**RE: Farnam Flats Apartments**  
Conversion of Commercial Space to Residential Living Units

Attached please find the petition application to change the existing mixed use Farnam Flats building to an all residential facility. In doing so, the existing 3,763 sf Commercial/Retail space on the lower level of Farnam Flats shall be converted to (4) residential living units. This request is consistent with the previously signed Development Agreement between Farnam Flats LLC and the Joint Development Commission. This conversion is required as the existing commercial space has been actively listed with a local commercial broker since the beginning of Construction and little to no interest has been received. It was originally Farnam Flats LLC's desire for this space to house a commercial operator which would have both serve the neighborhood and provided an excellent amenity to its building occupants, but to date there has been no interest in the space mostly due to the current economic climate created by the COVID-19 pandemic.

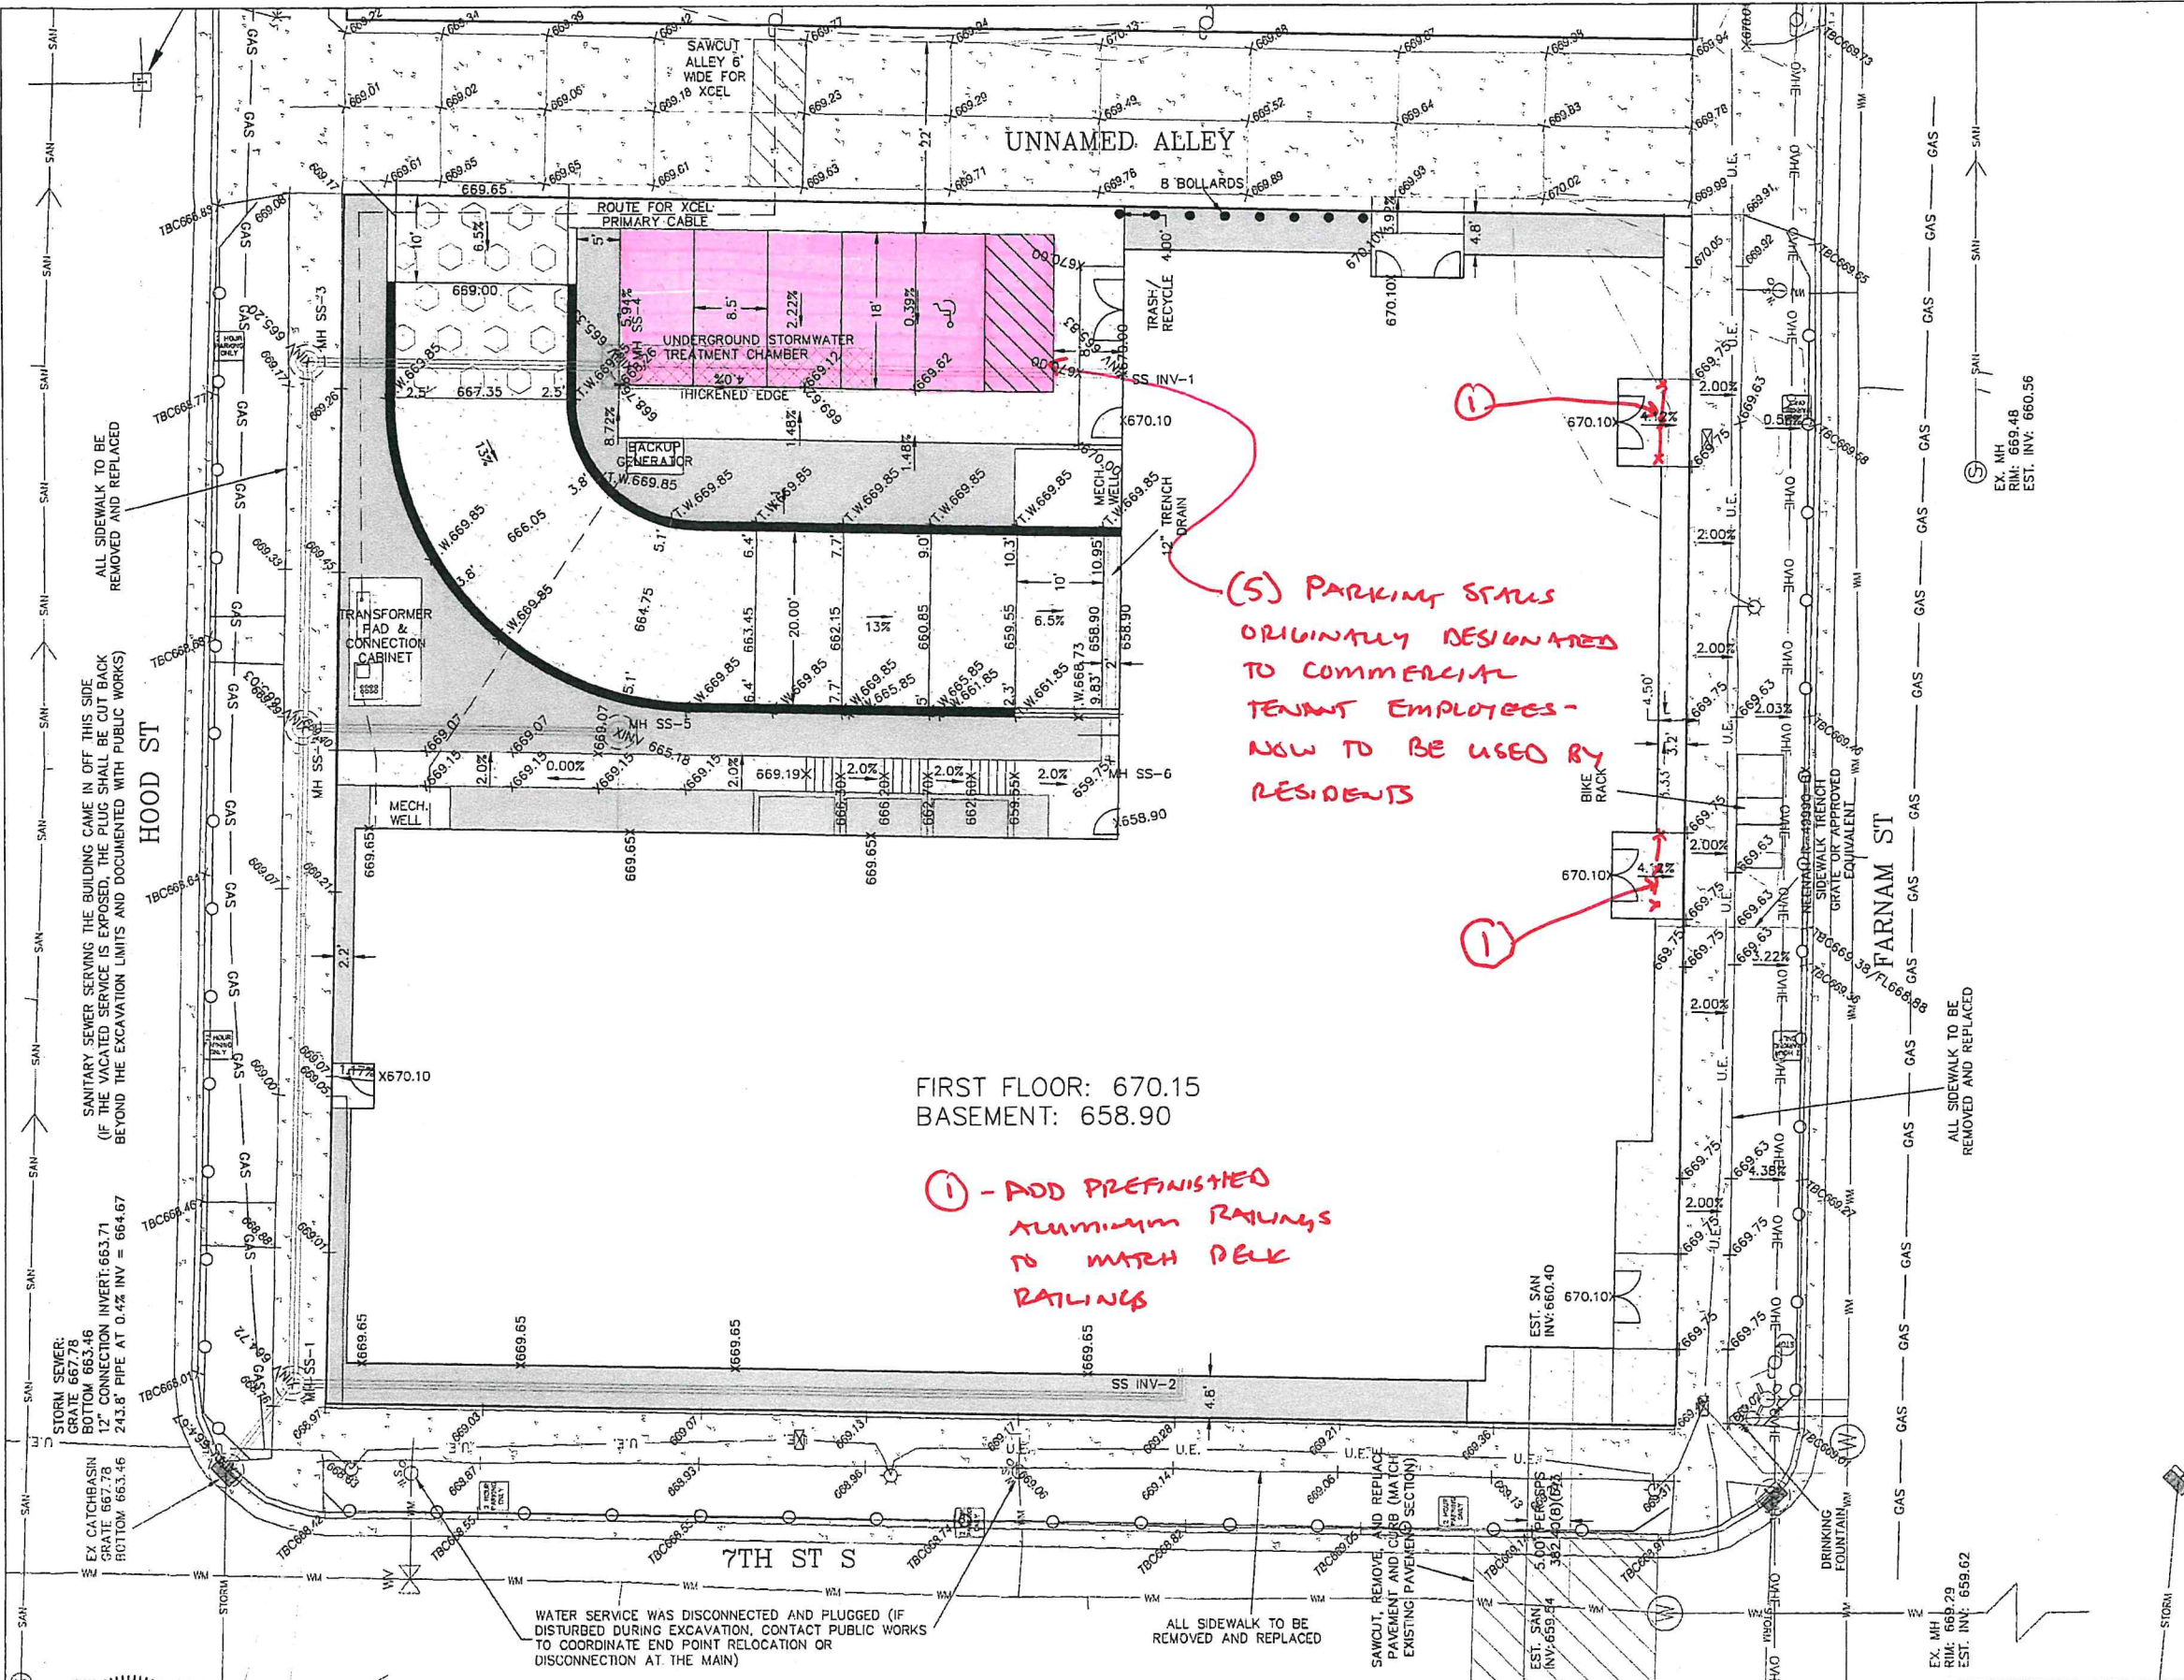
*(S) PARKING STALLS  
 ORIGINALLY DESIGNATED  
 TO COMMERCIAL  
 TENANT EMPLOYEES -  
 NOW TO BE USED BY  
 RESIDENTS*

*① - ADD PREFINISHED  
 ALUMINUM RAILINGS  
 TO MATCH PEAK  
 RAILINGS*

1 FUTURE TENANT LAYOUT  
ORIGINAL SCALE: 1/4" = 1'-0"

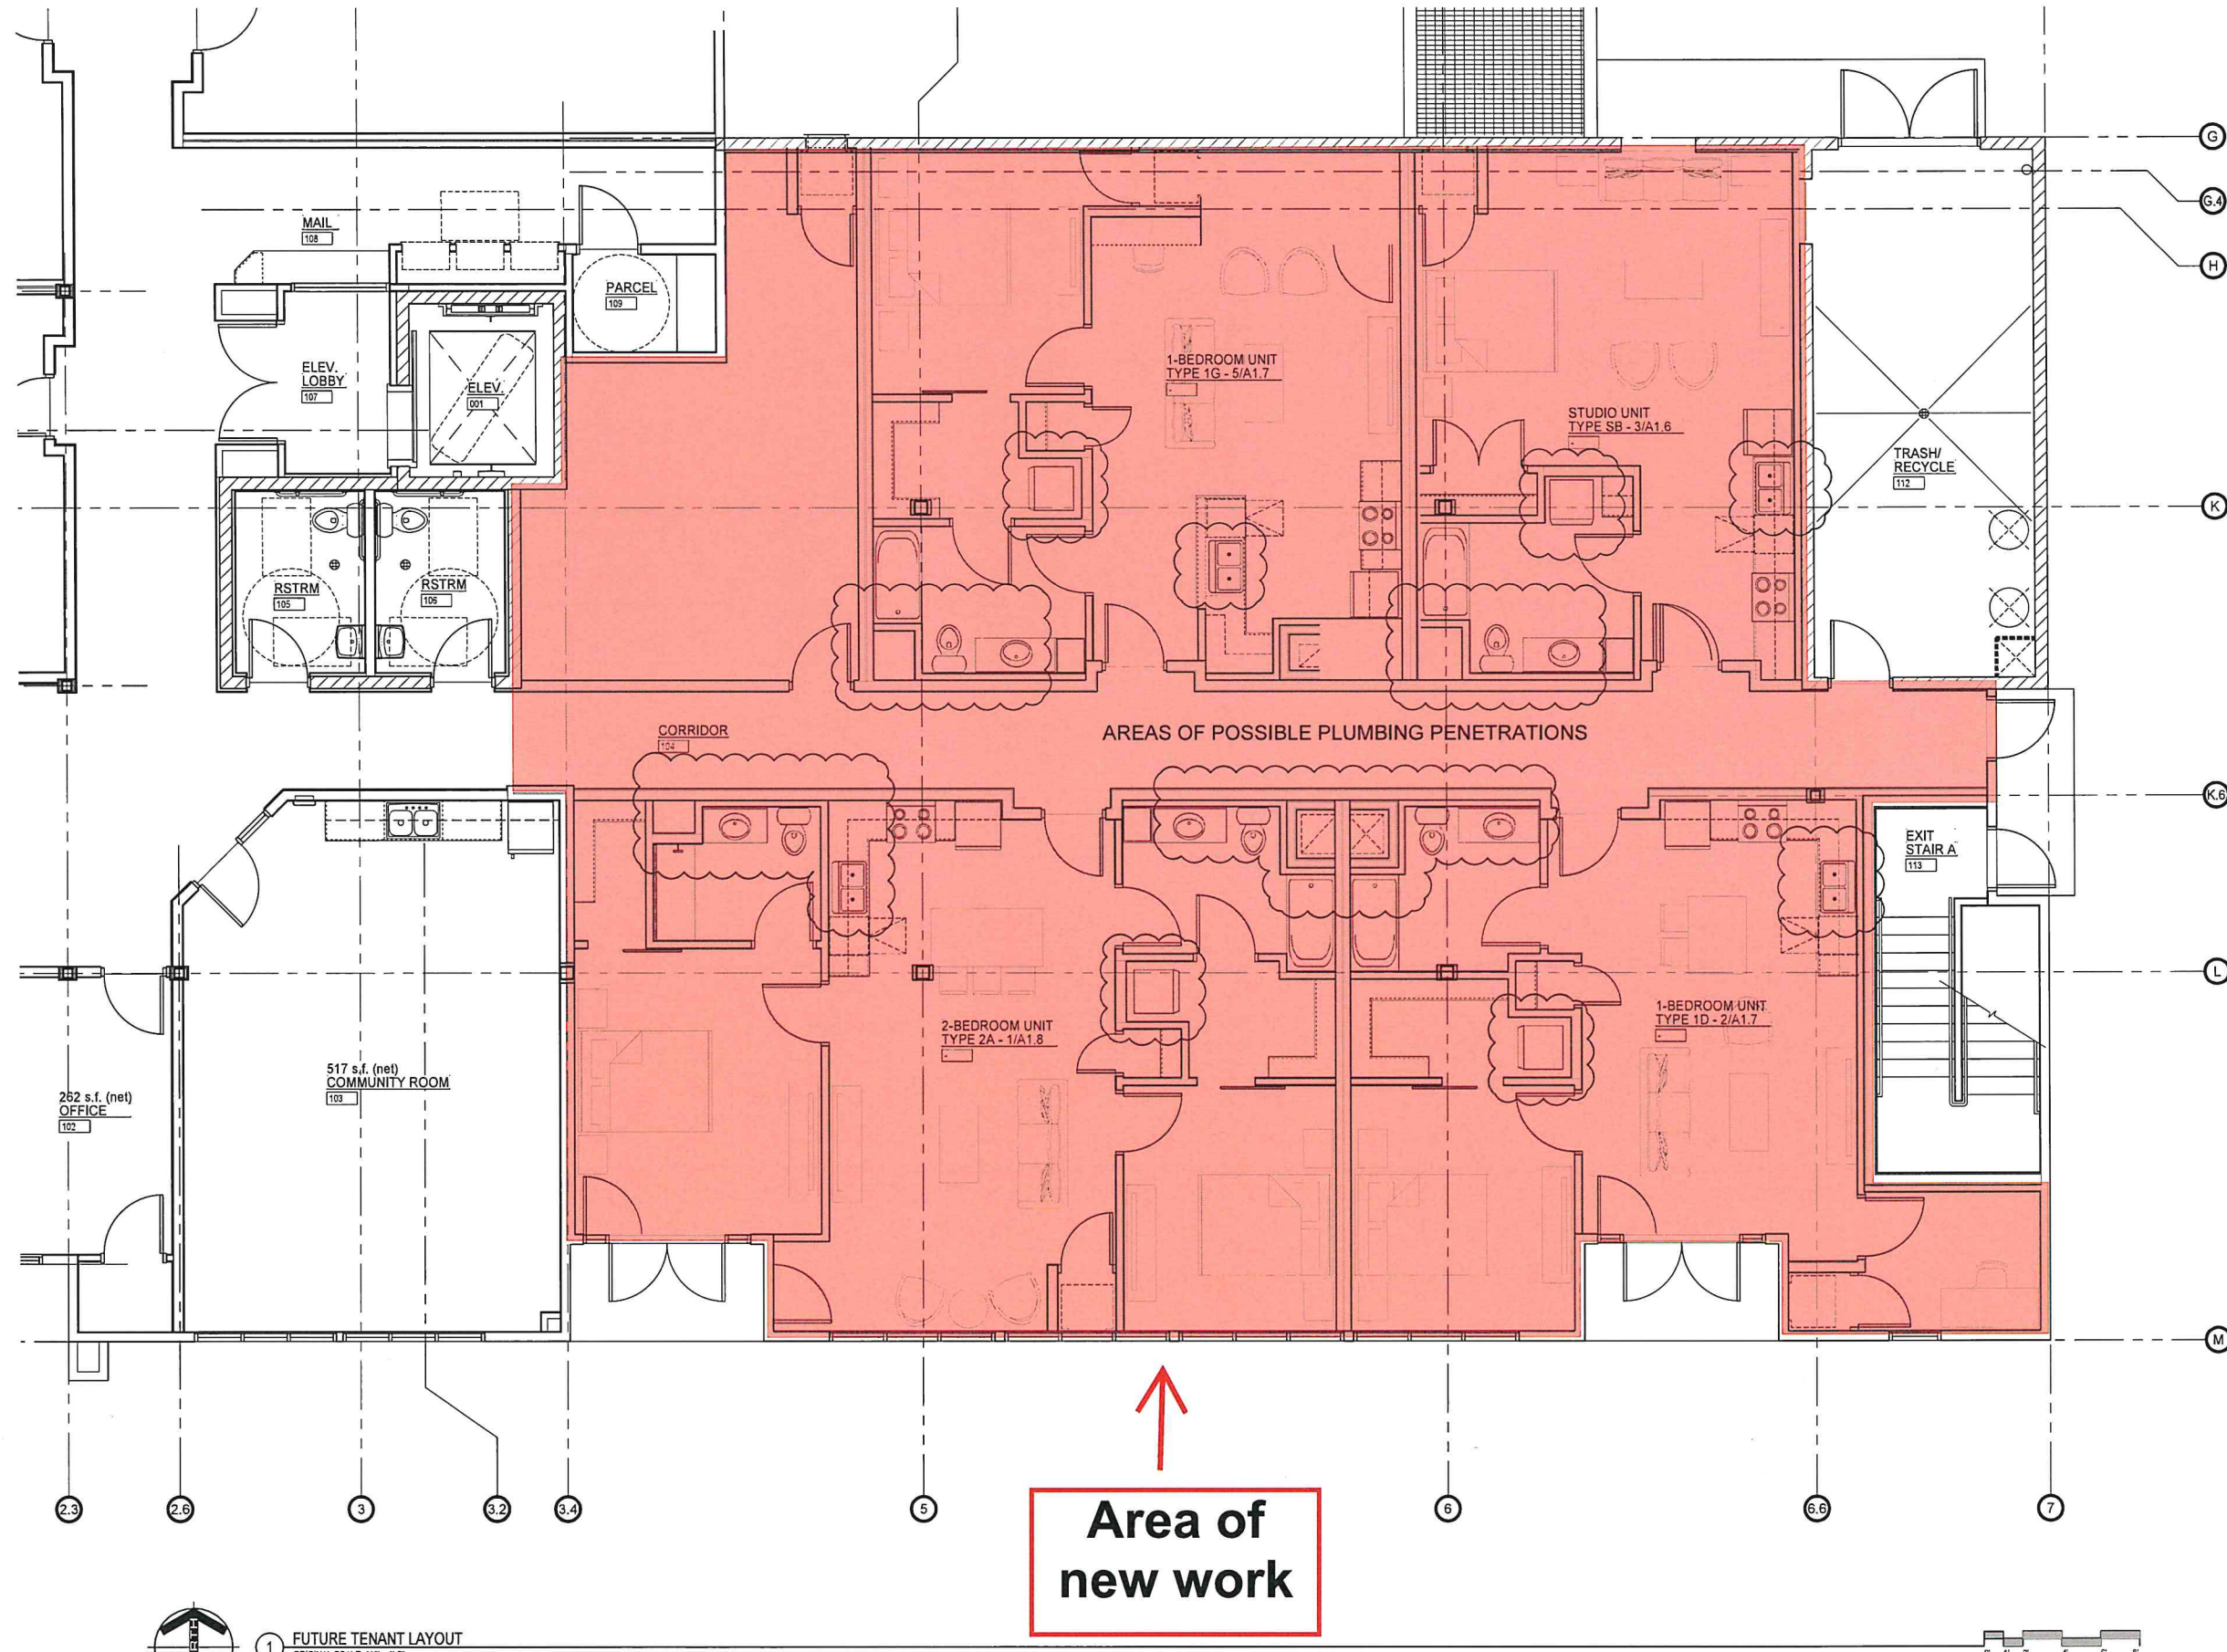
Area of new work

**FARNAM STREET FACADE**  
**1 SOUTH ELEVATION**  
ORIGINAL SCALE: 1/8" = 1'-0"

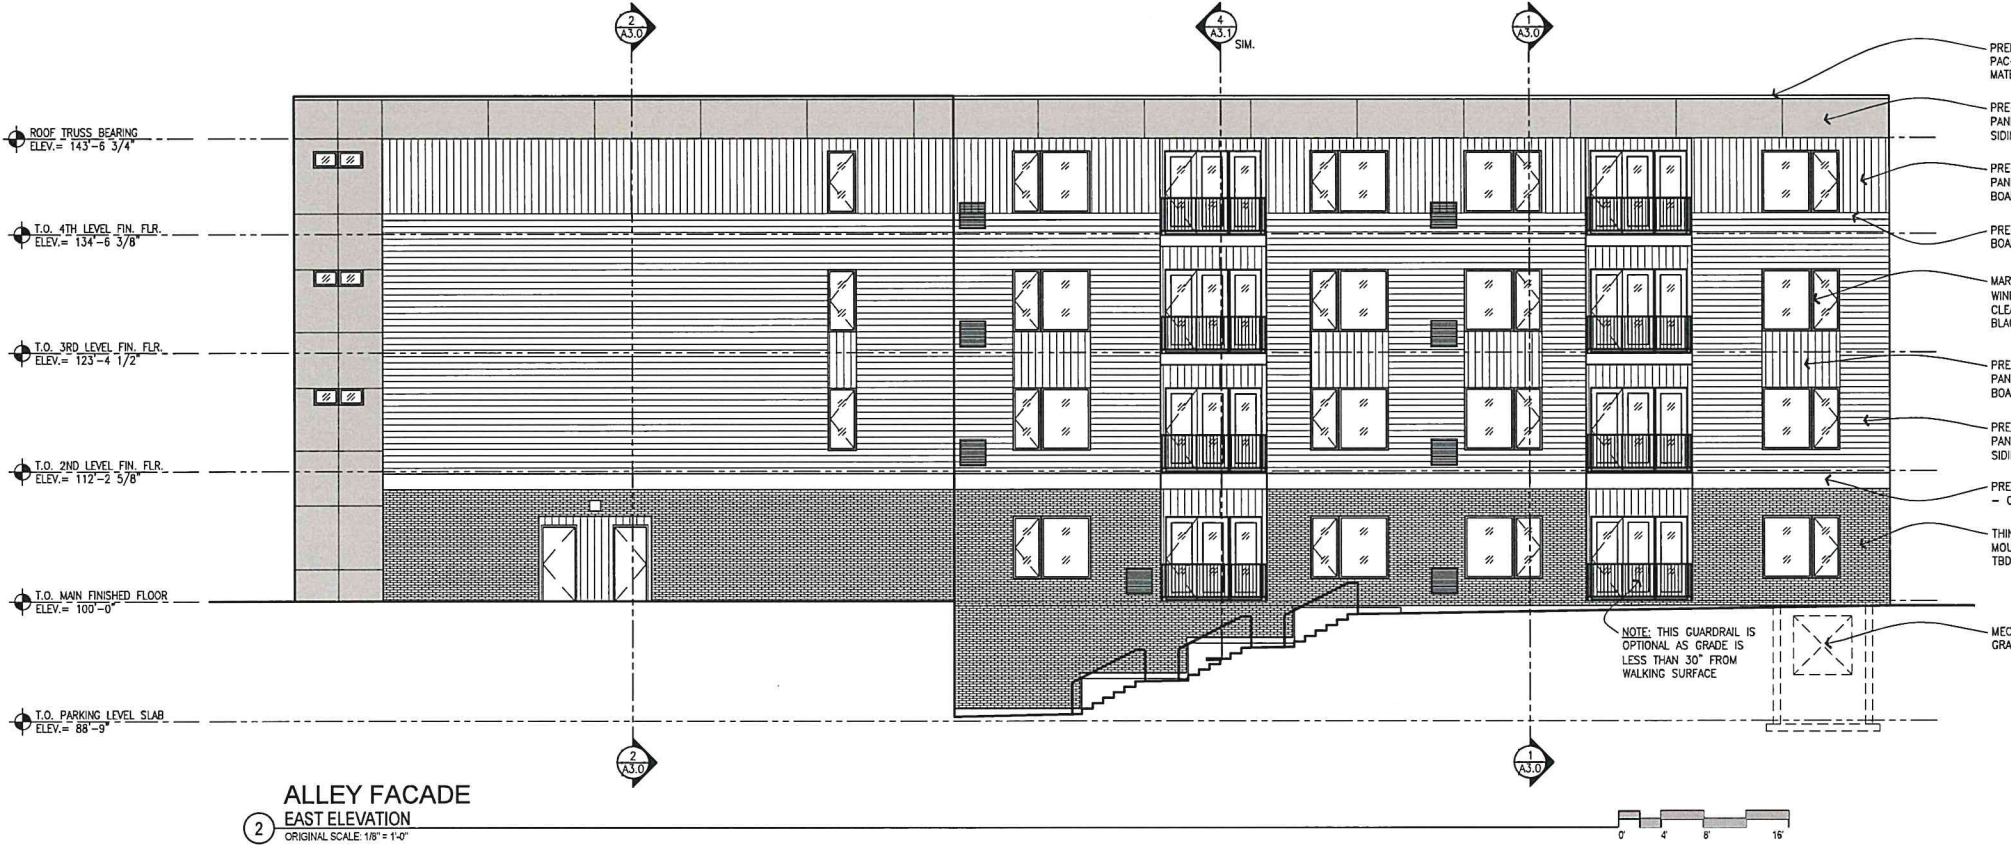
*ADD HORIZONTAL MULLION + BREAK-OFF PANELS C BOTTOM 42" OF EXISTING ALUMINUM STOREFRONTS*

*INSTALL PREFINISHED ALUMINUM RAILINGS TO MATCH EXISTING DECK RAILS*
